RE: Draft Subsequent Environmental Impact Report (SDEIR)
San Jose City College Facilities Master Plan Update 2021

**Review of Supplemental Draft Environmental Report
San Jose City College Facilities Master Plan Update 2021**

Figure 5

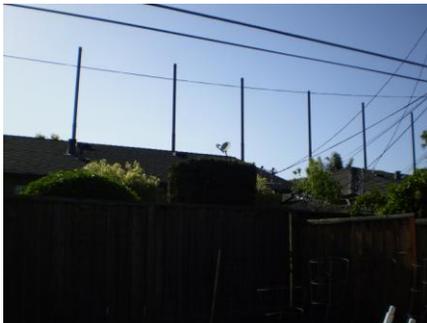
Figures 1-4 show front views of home on Richmond Avenue. These homes face away from the campus. Eichler homes were designed to integrate the use of inside and outside living space. The wall that faces the campus is at least 50% glass, allowing a full view from the kitchen, living and dining room areas. Figures 1-4 also represent the front yard view from the homes across the street. Figures 5 and 6 represent backyard and dining room/living room views. These shots had to be taken closer to the fenceline because views from inside the homes or the patios directly outside cannot show the tops of the poles. Views from patios and inside are completely enclosed in proposed poles/nets.

Figure 10

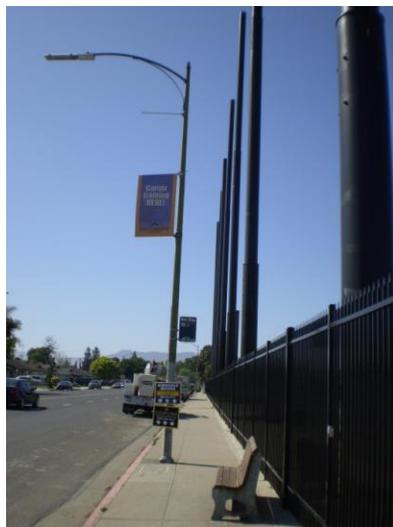
Figures 10, 11 and 12 are views along Leigh Avenue. The fence line abuts the sidewalk. This leaves no room for tree replacement or any softening of the structure. Planting anything along the wooden wall will produce material that impedes on the sidewalk. Residents noted that the shadows cast by the poles extend more than a block away
